**Regulation No. 118 (Burning behaviour of materials)**

### **Proposal for amendments to Regulation No. 118 (Burning behaviour of materials)**

#### **Submitted by the experts from Finland, France and Germany \***

"Figure 1  
**Specimen holder** (Dimensions in millimetres)

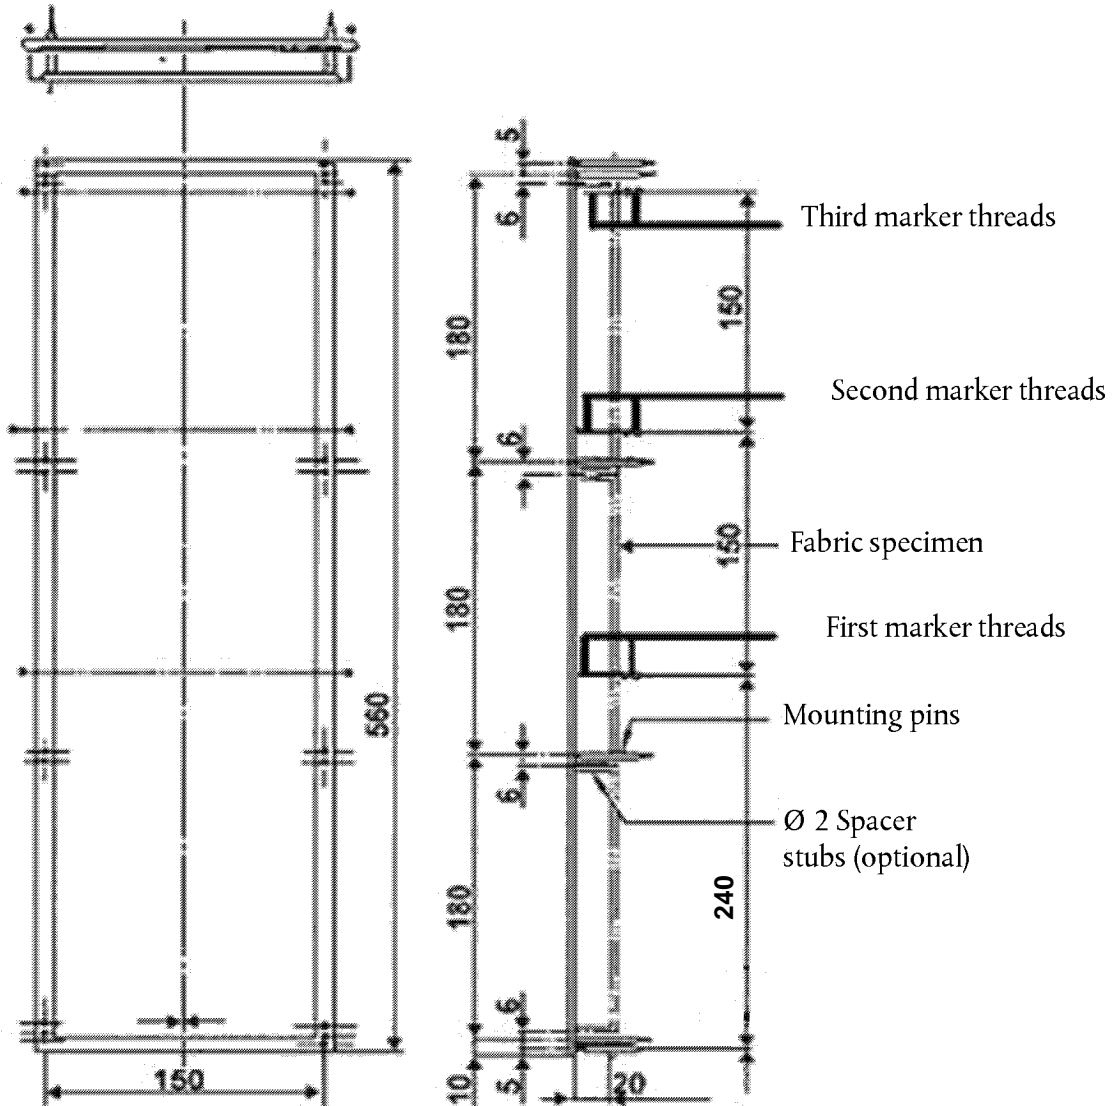
Figure 1, amend to read (removing "Burner" at the bottom and replacing "220" by "240"):

**The specimen holder shown in Figure 1 may be modified in width to allow the fixation of the sample.**

**Figure 1**  
**Apparatus for resistance to flame propagation (Dimensions in millimetres)**

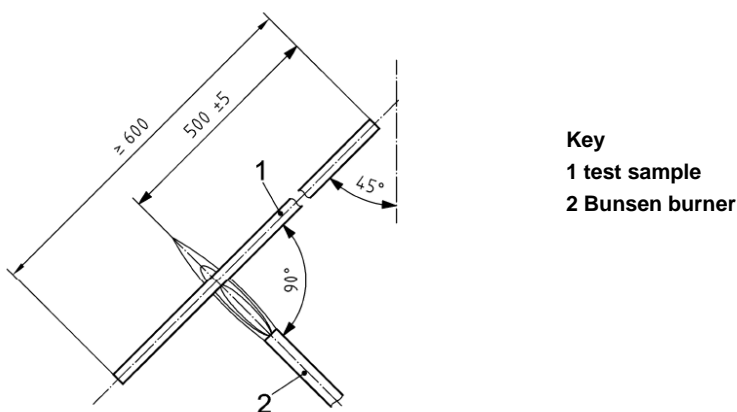
Suspend the test sample in a draught-free chamber and expose the test sample to the tip of the inner cone of the flame, as shown in Figure 1. The upper end of the cable shall point away from the closest wall of the chamber. The sample shall be subject to a stress, e.g. by means of a weight over a pulley, in order to keep it straight at all times. The angle of the cable shall be  $45^\circ \pm 1^\circ$  relative to the vertical line. In any case, the shortest distance of any part of the sample shall be 100 mm minimum from any wall of the chamber. Apply the flame with the tip of the inner blue cone touching the insulation  $(500 \pm 5)$  mm from the upper end of the insulation.
